CONSTRUCTION SUMMARY		RECEIVED
Red Oaks on Bayview - Trinimont Developments Inc.		DEC - 2 2022
PURCHASER: HUAN JIANG		TEL:

LOT / PHASE 94 / 1	REG. PLAN # 65M-4737	HOUSE TYPE Birch 2 Elev C		
-----------------------	-------------------------	------------------------------	--	--

BIRCH 2
ELEV C.

41-2 GROUND FLOOR PLAN EL. C - 10' CEILING

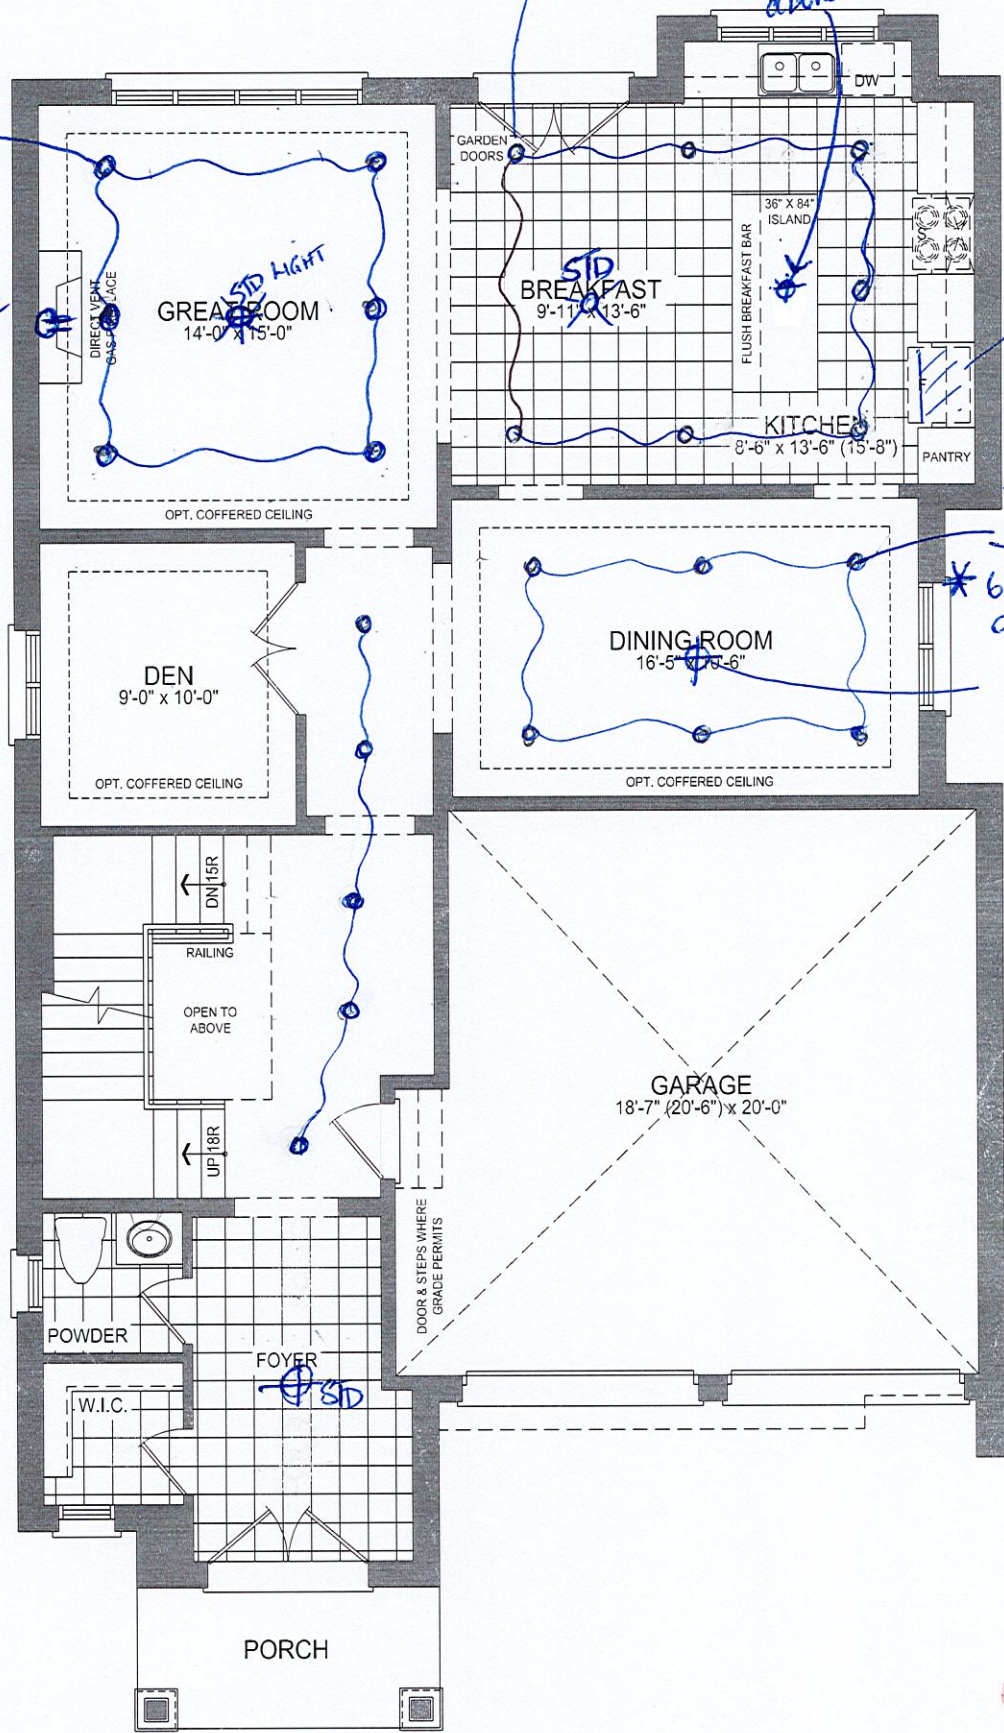
* 7 POTLIGHTS ON 1 SWITCH

* Relocate light
+ center
above island

FAMILY RM
* 6 potlights
1 switch
* std light to
remain
* plug above fireplace

FULL DEPTH
FRIDGE UPPER

* 6 POTLIGHTS
ON 1 SWITCH

STANDARD
LIGHT TO
REMAIN

MAIN HALL
* 5 POTLIGHTS
ON 1 SWITCH
* delete standard
reg. voltage lights
in main hall.

* SMOOTH CEILING (MAIN FLOOR
+ 2ND FLOOR)

★ BASEMENT WALK-UP.

41-2 SECOND FLOOR PLAN EL. C - 9' CEILING

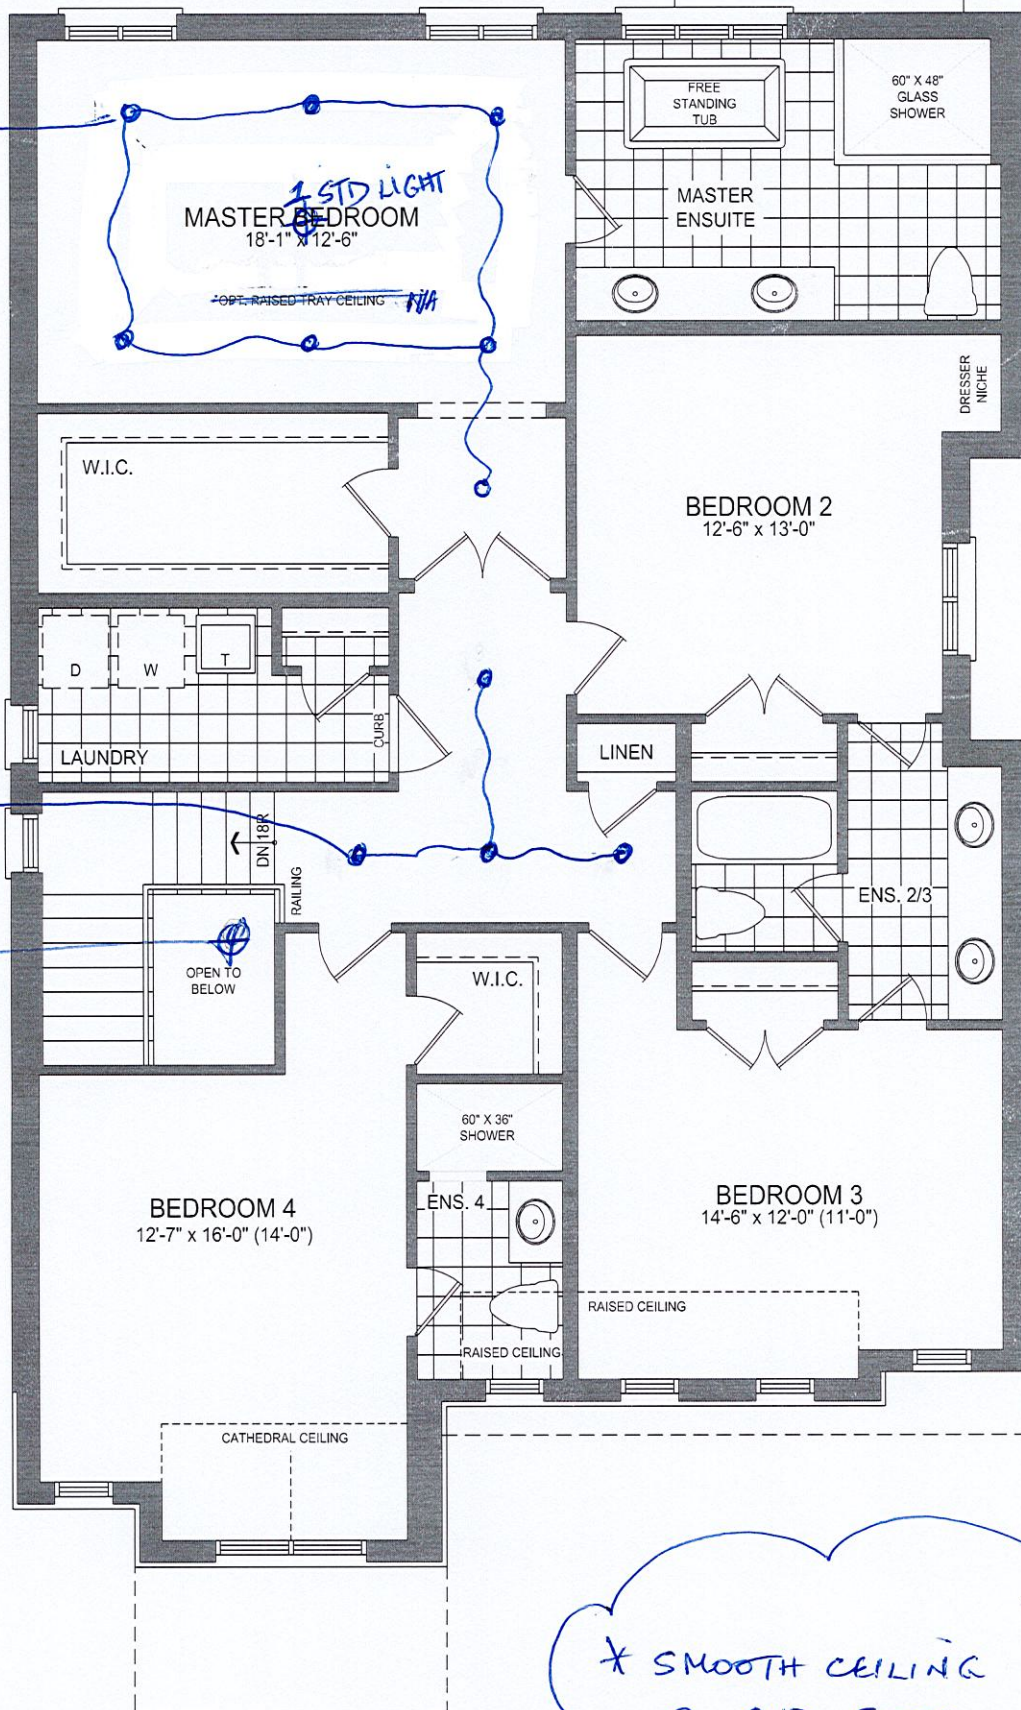
* 7 POTLIGHTS ON 1 SWITCH

* INSTALL ONE STANDARD LIGHT ON SEPARATE SWITCH

4 POTLIGHTS
ON 1 SWITCH

STD
LIGHT
TO REMAIN
ON
SEPARATE
SWITCH

* SMOOTH CEILING
@ 2ND FLOOR

41-2 BASEMENT PLAN EL. C

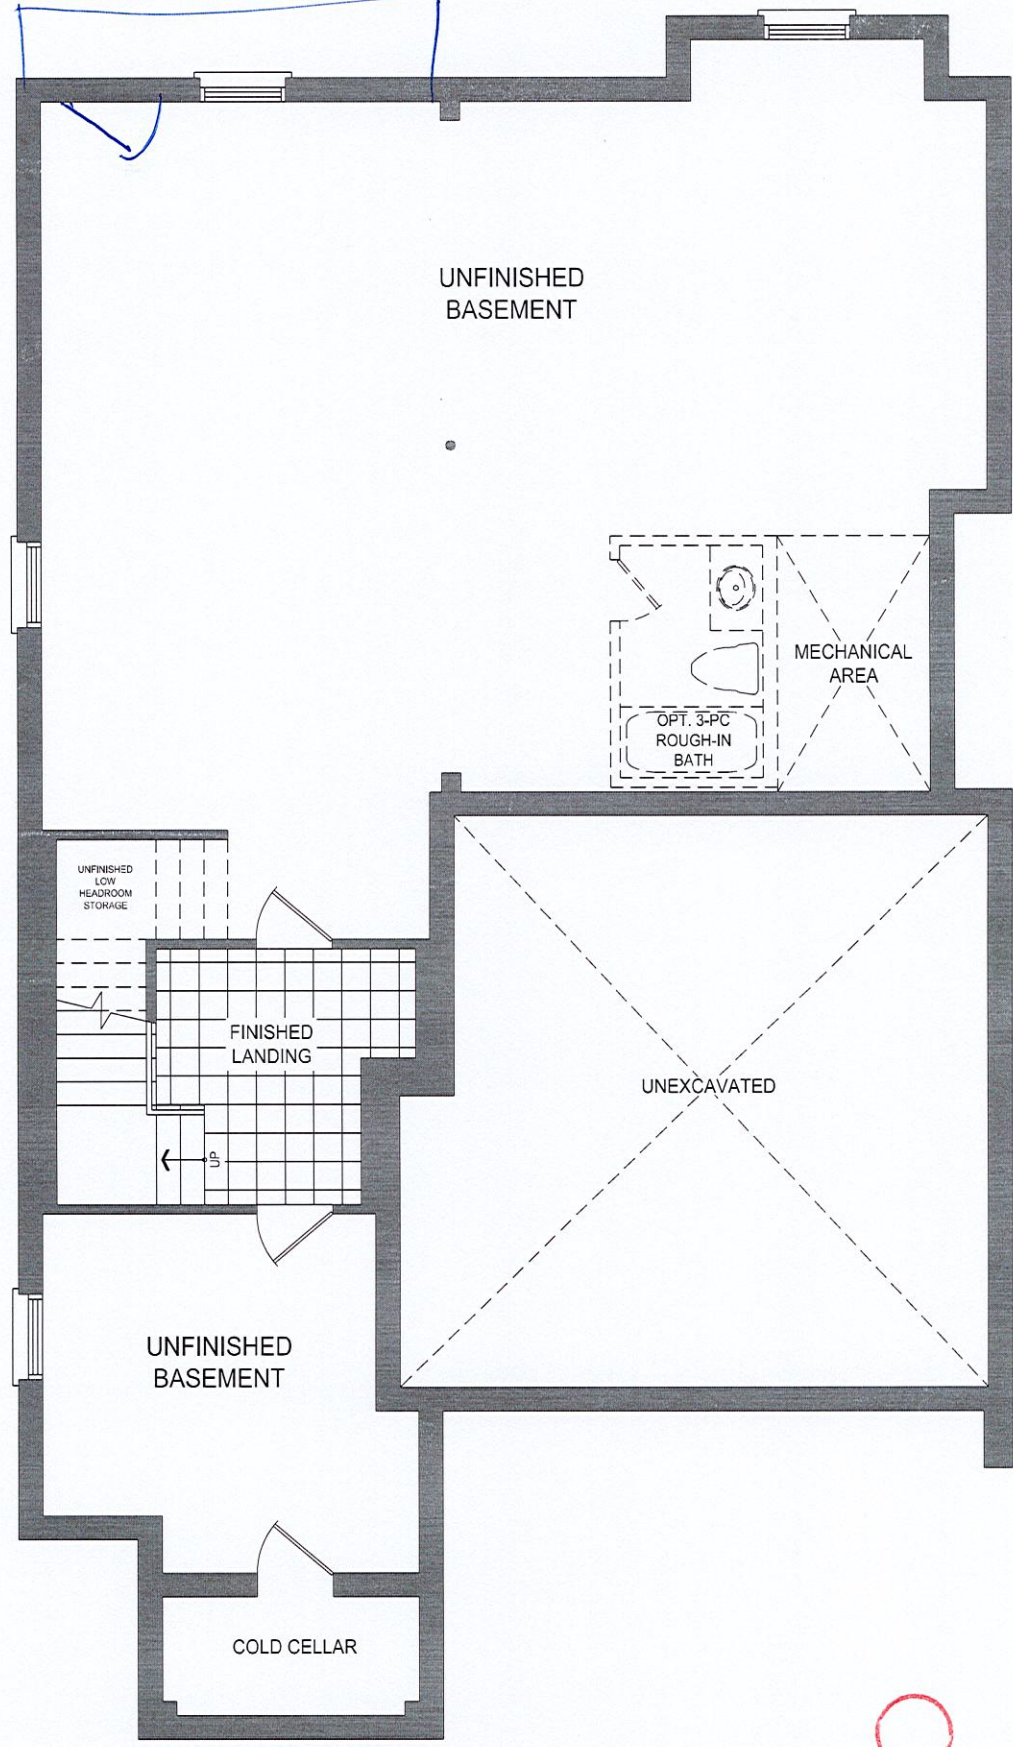
* BASEMENT WALK-UP

BIRCH 2
ELEVATION C

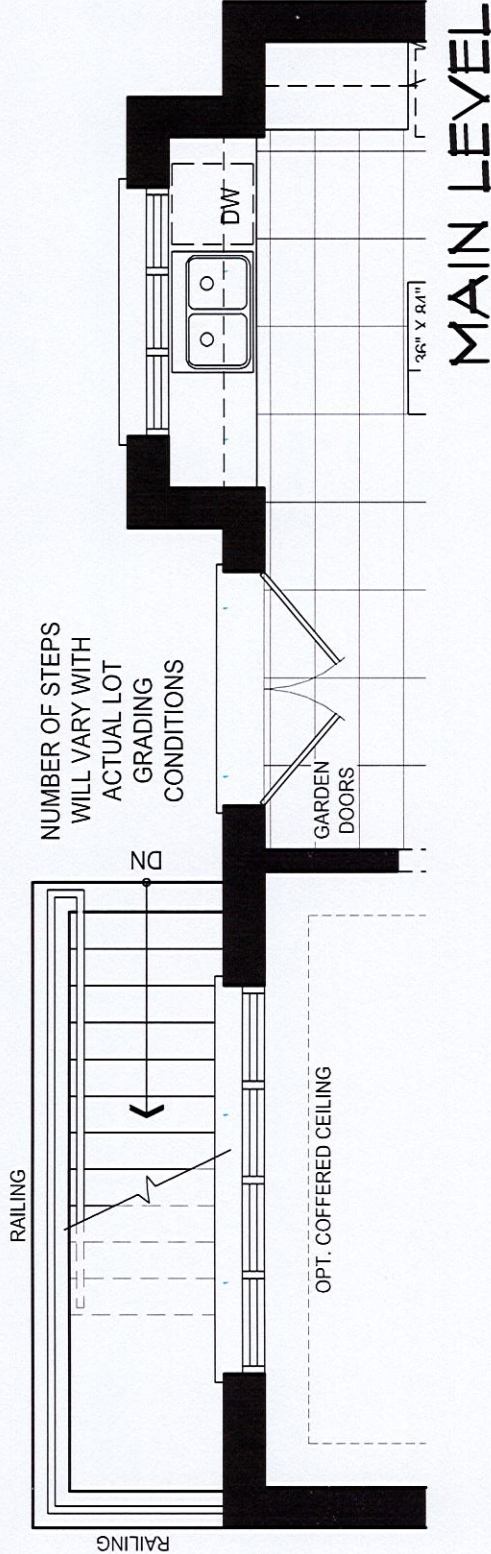
1. ADD EXTERIOR BASEMENT WALK-UP STAIRS TO REAR OF HOUSE.
